CITY OF VINELAND

**RE: Street Lighting Recommendations  
September 2017**

## STREET LIGHTING RECOMMENDATIONS

SEPTEMBER 2017

<b>PROPOSED STREET LIGHT REVISION</b> AREA OF WEST BLVD BETWEEN CHESTNUT AVENUE AND GRANT AVENUE	
<b>VINELAND MUNICIPAL ELECTRIC UTILITY</b> <b>VINELAND, NEW JERSEY</b>	
DRAWN: CAM	VAULT # F-3-C
DATE: 8/7/2017	DRAWING # VMEU-2842
SCALE: NTS	CHECKED:

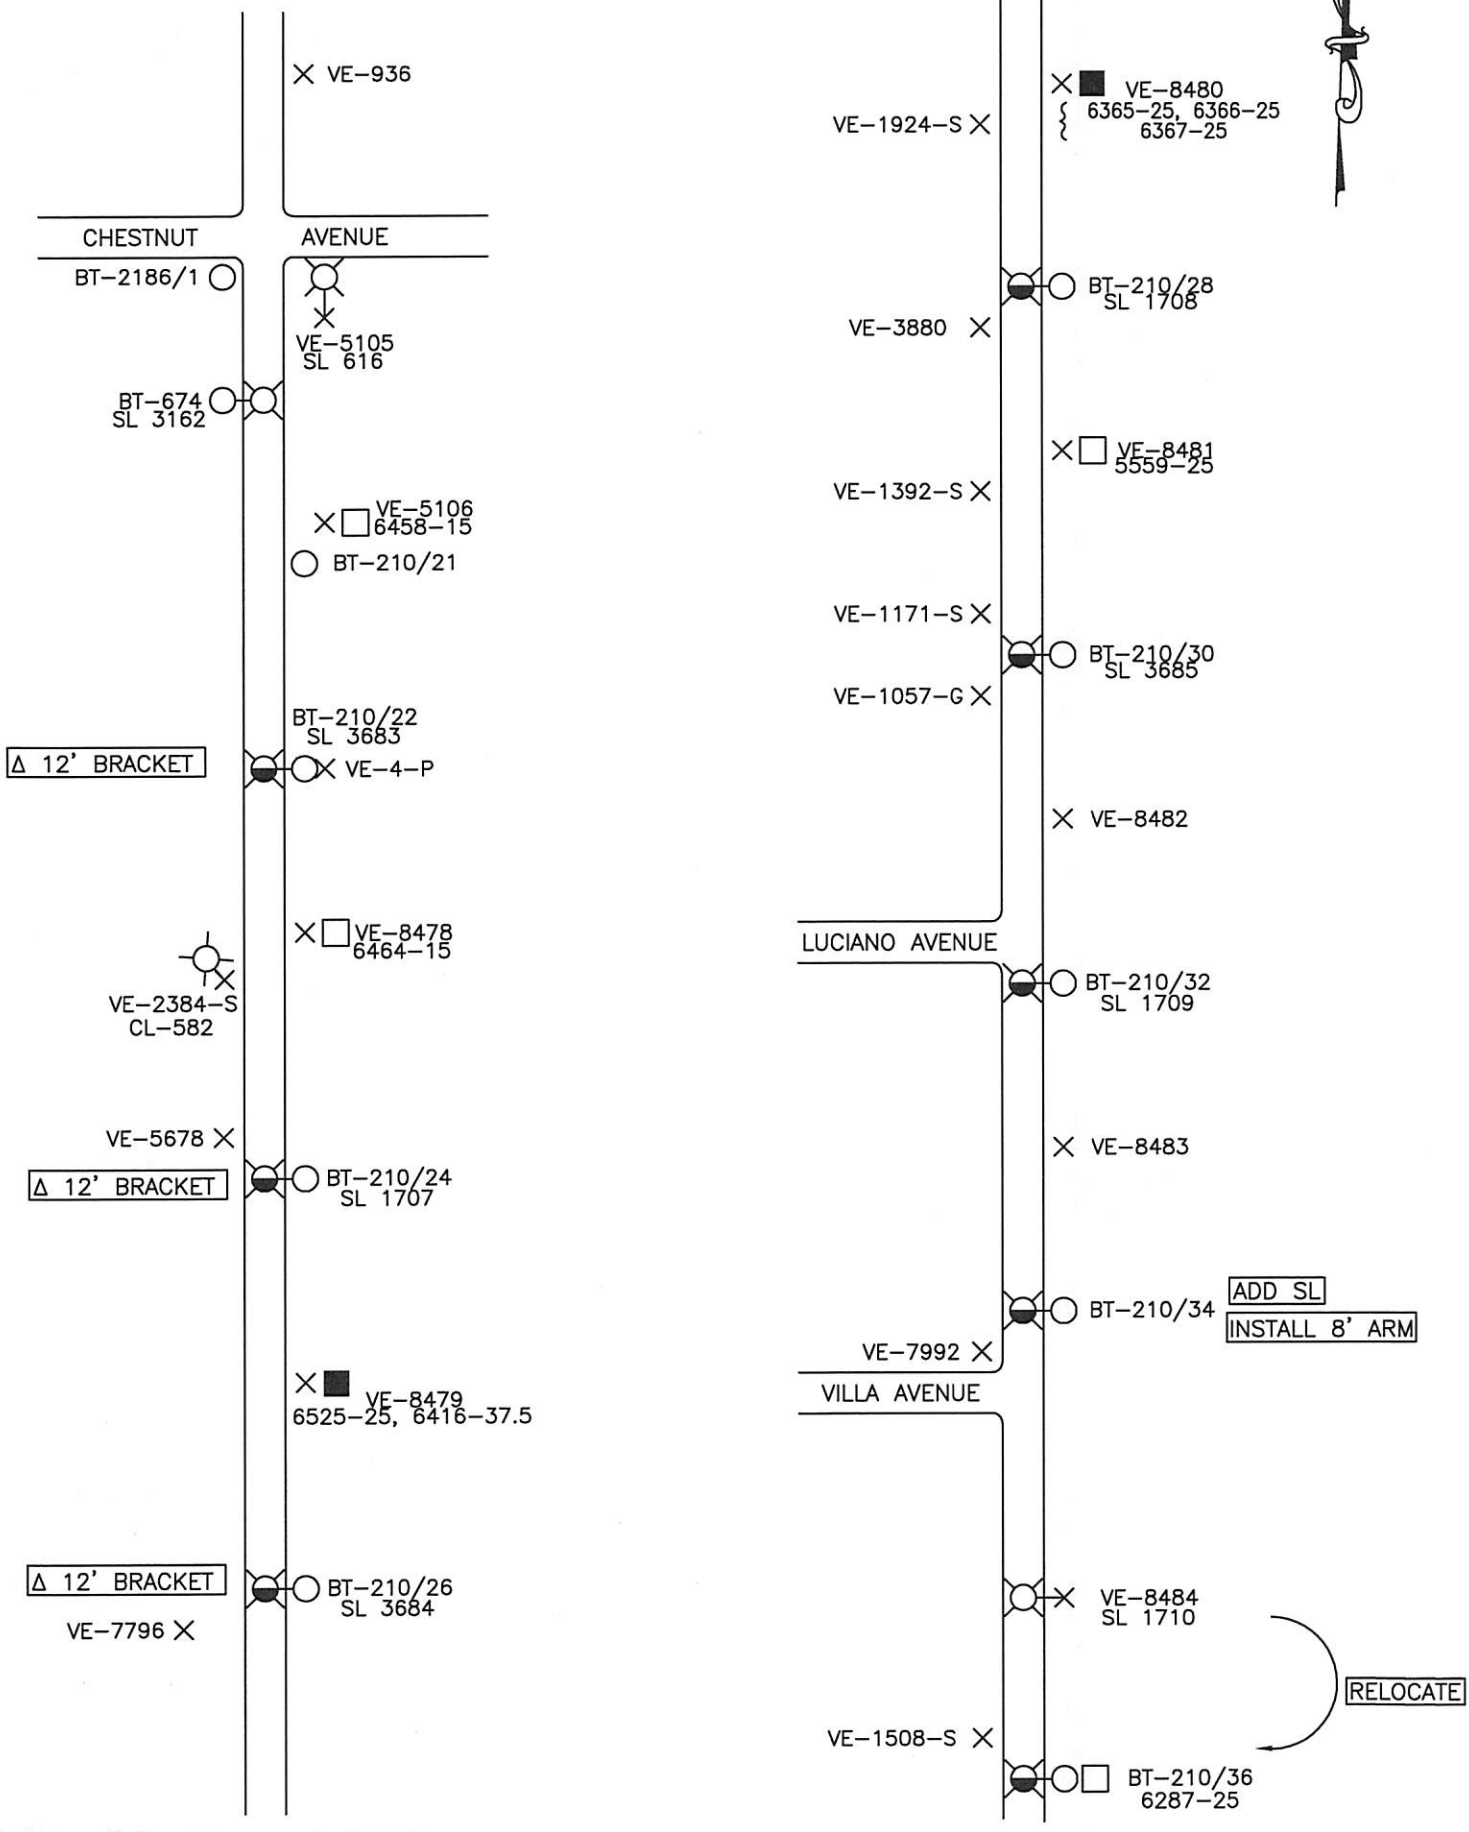
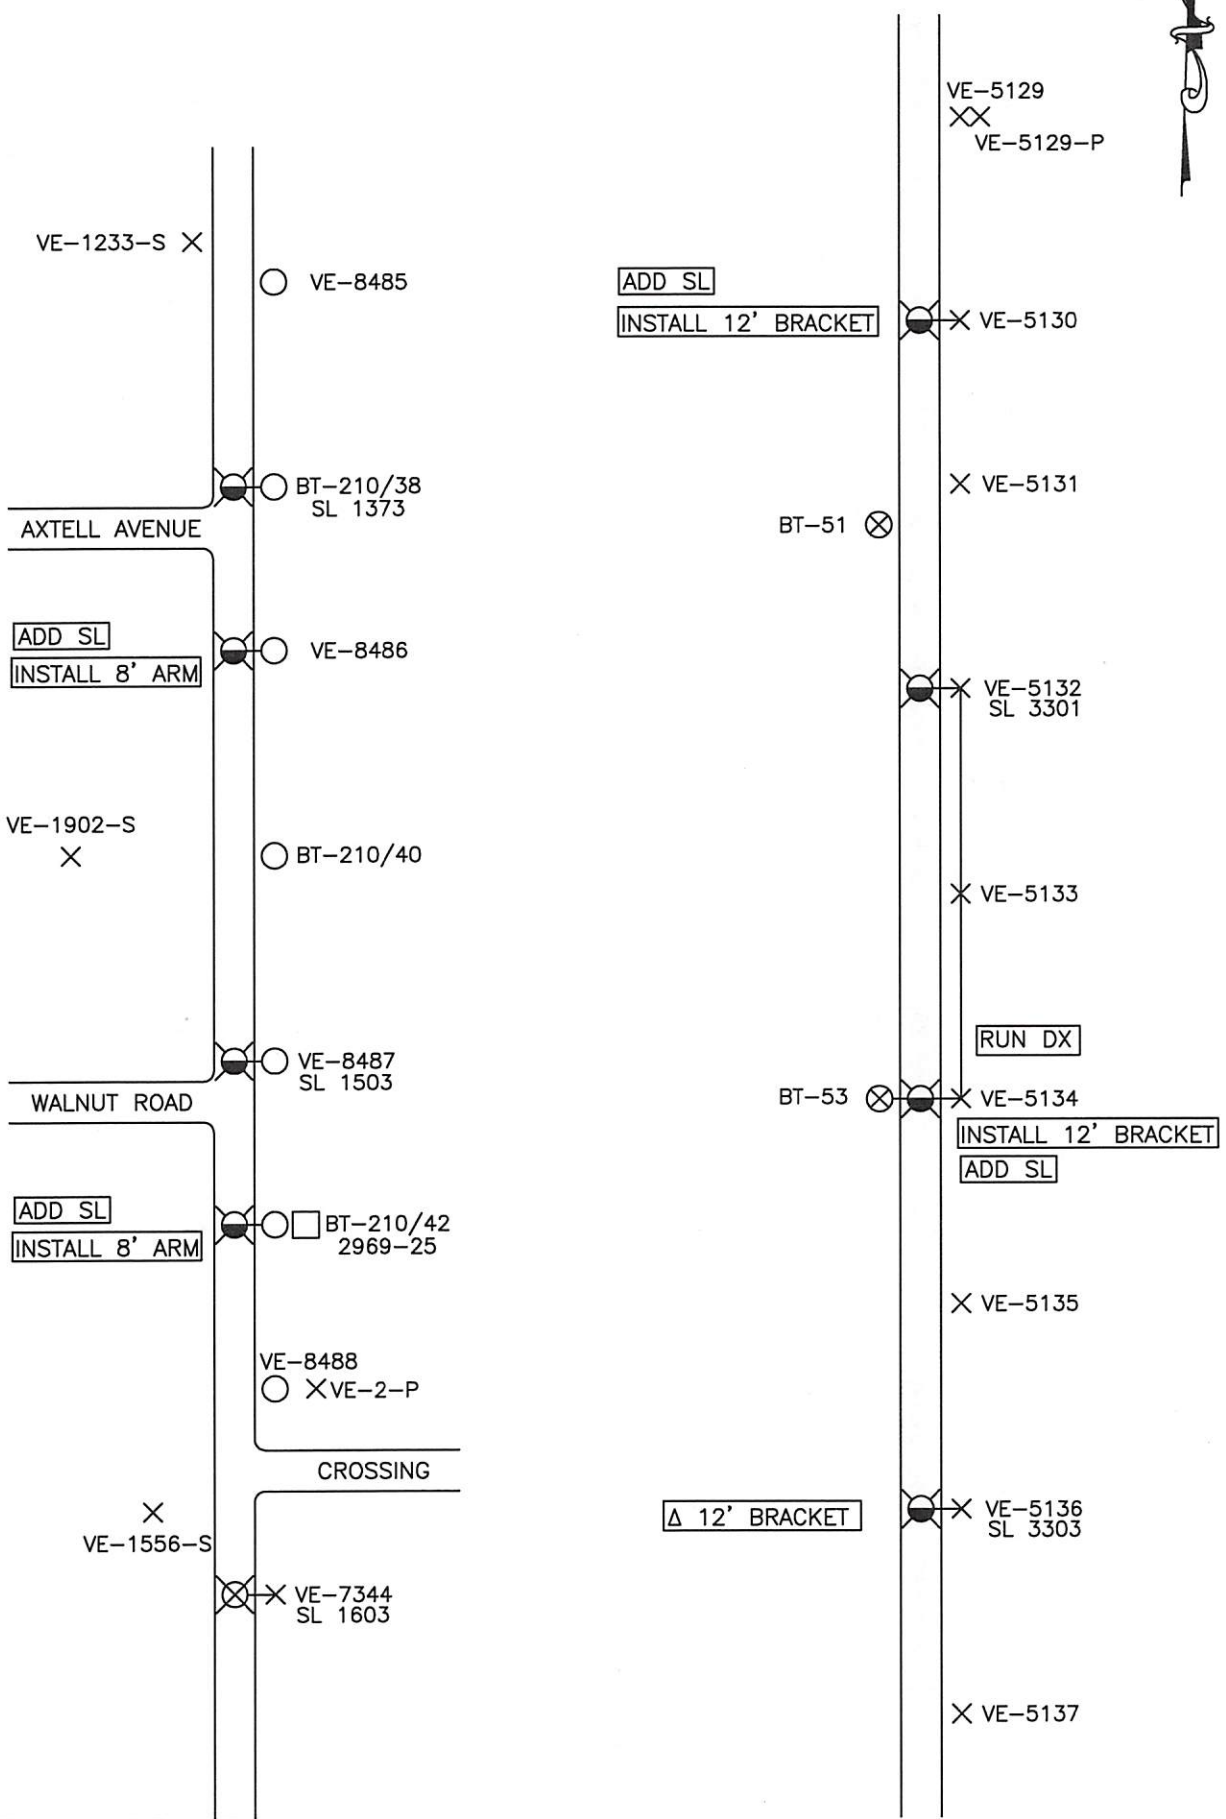
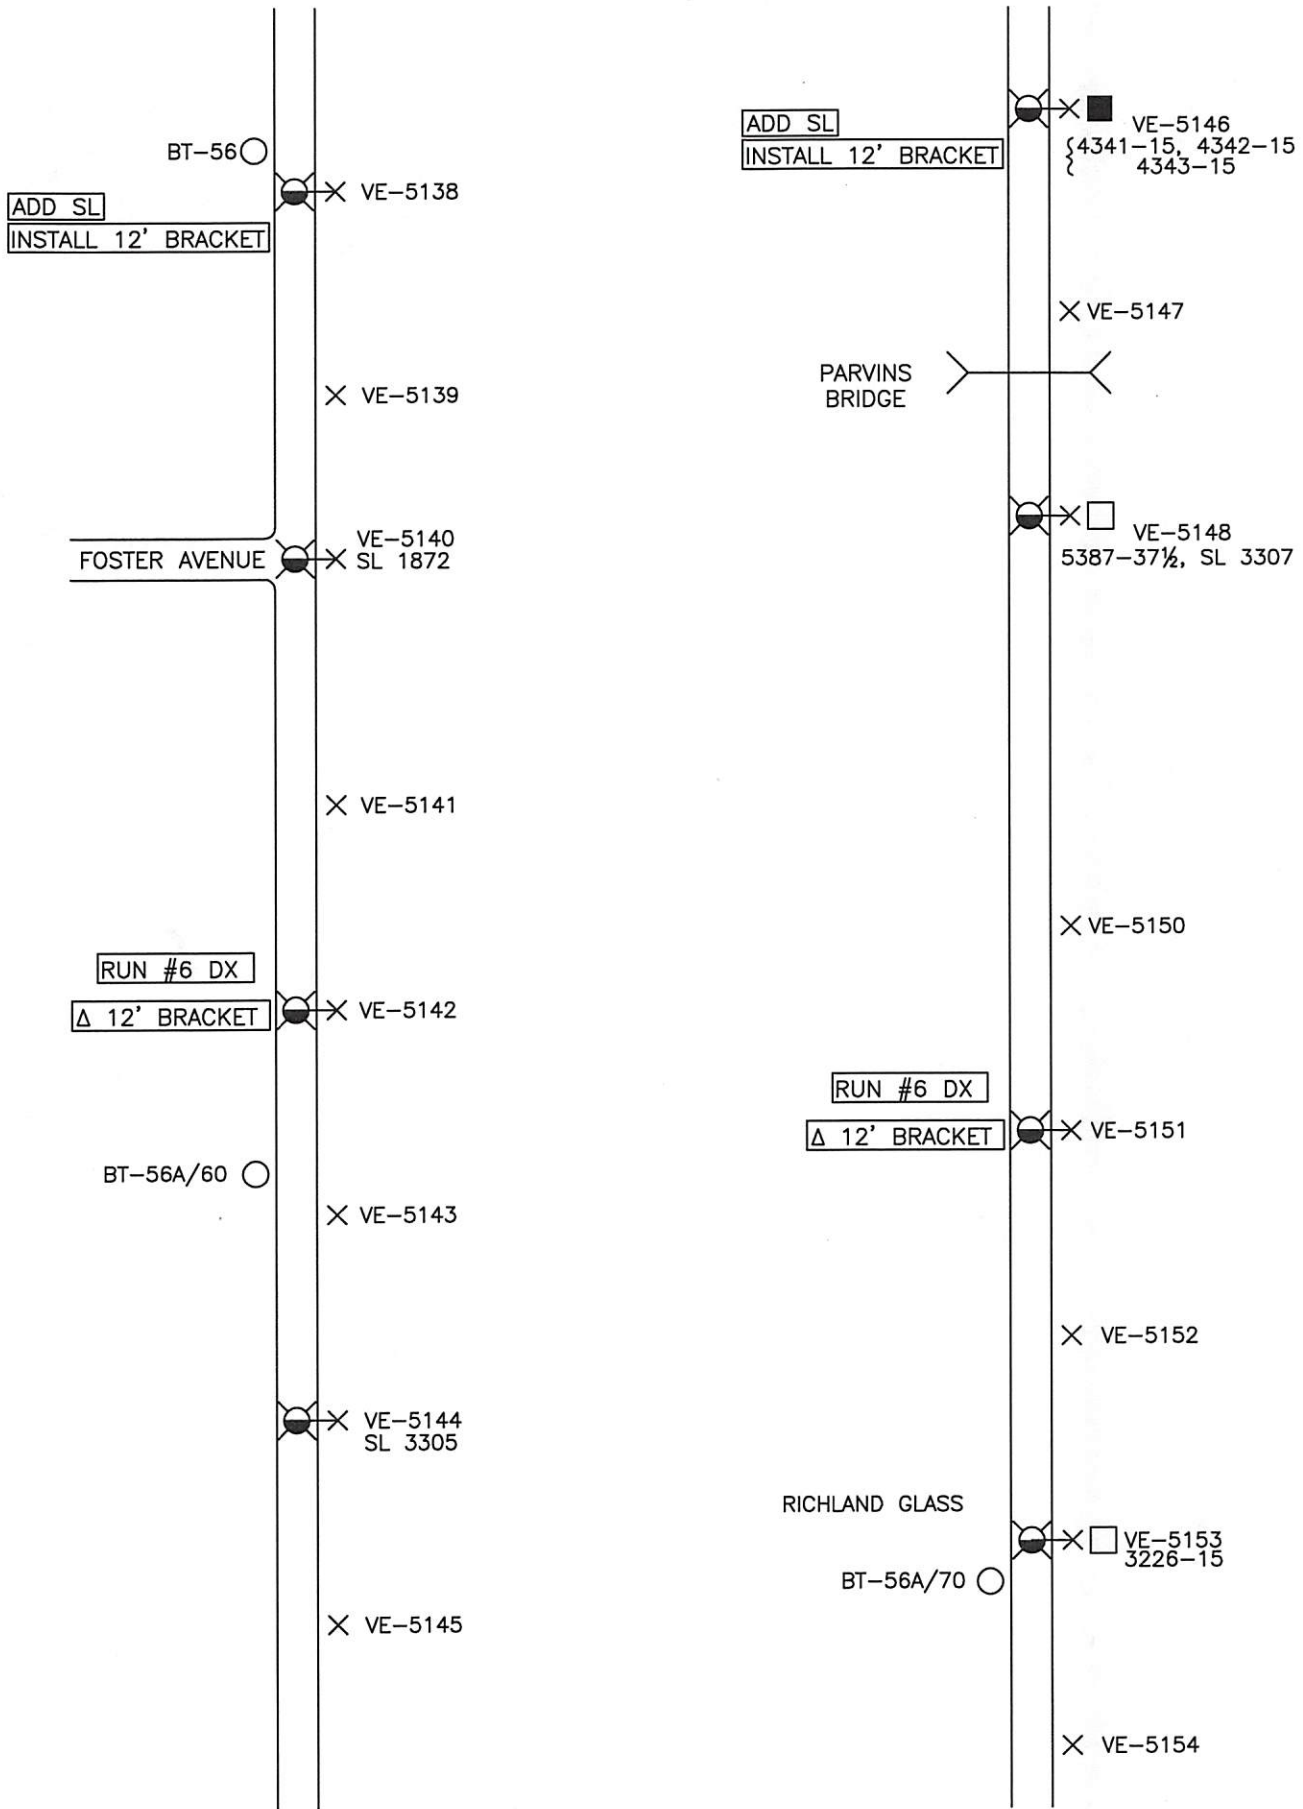
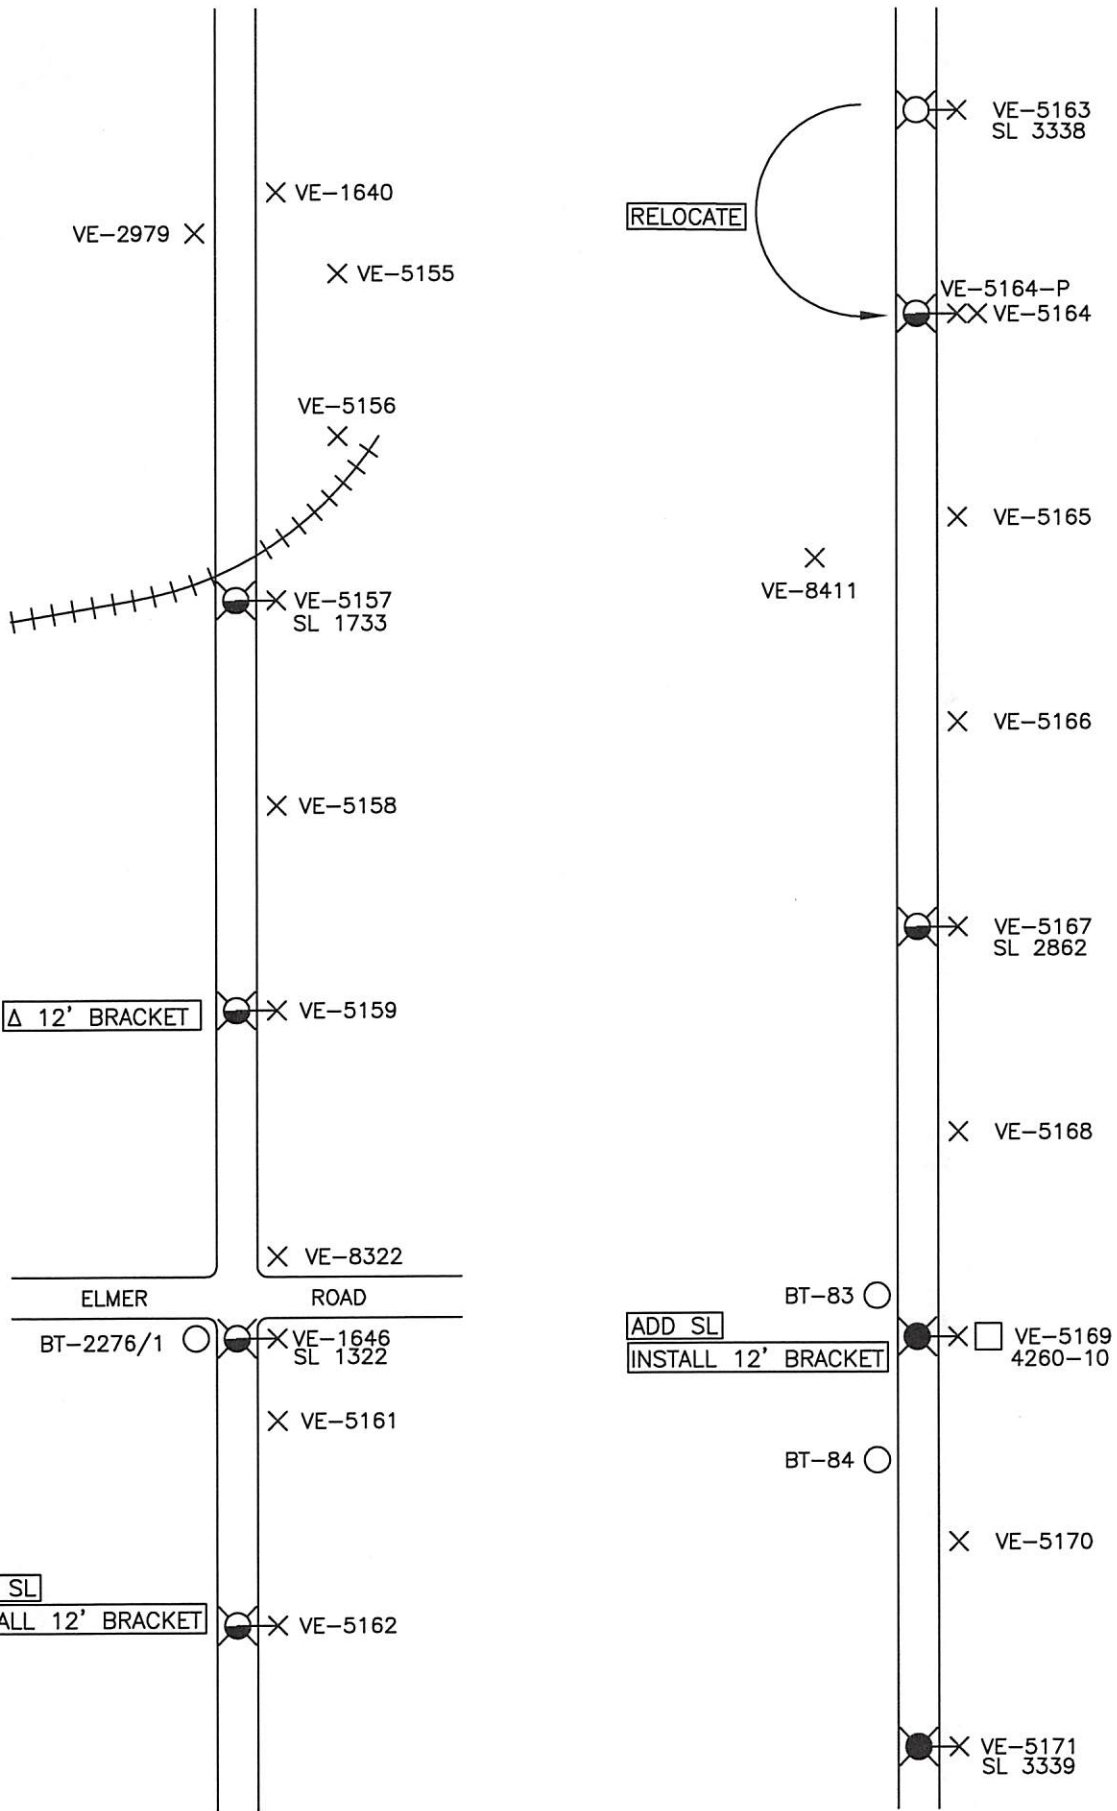
4. Area of West Boulevard  
*(between Chestnut Ave & Grant Ave)*  
Drawing No. VMEU-2842  
Upgrade four (4) existing street lights to 74W LED, twenty-two (22) to 108W LED (relocating two), and one (1) to 160W LED. Install an additional one (1) 74W LED, and eight (8) 108W LED street lights onto existing utility poles.

**PROPOSED:** Upgrade four (4) existing street lights to 74W LED, twenty-two (22) to 108W LED (relocating two), and one (1) to 160W LED. Install an additional one (1) 74W LED, and eight (8) 108W LED st. lts. onto existing utility poles.
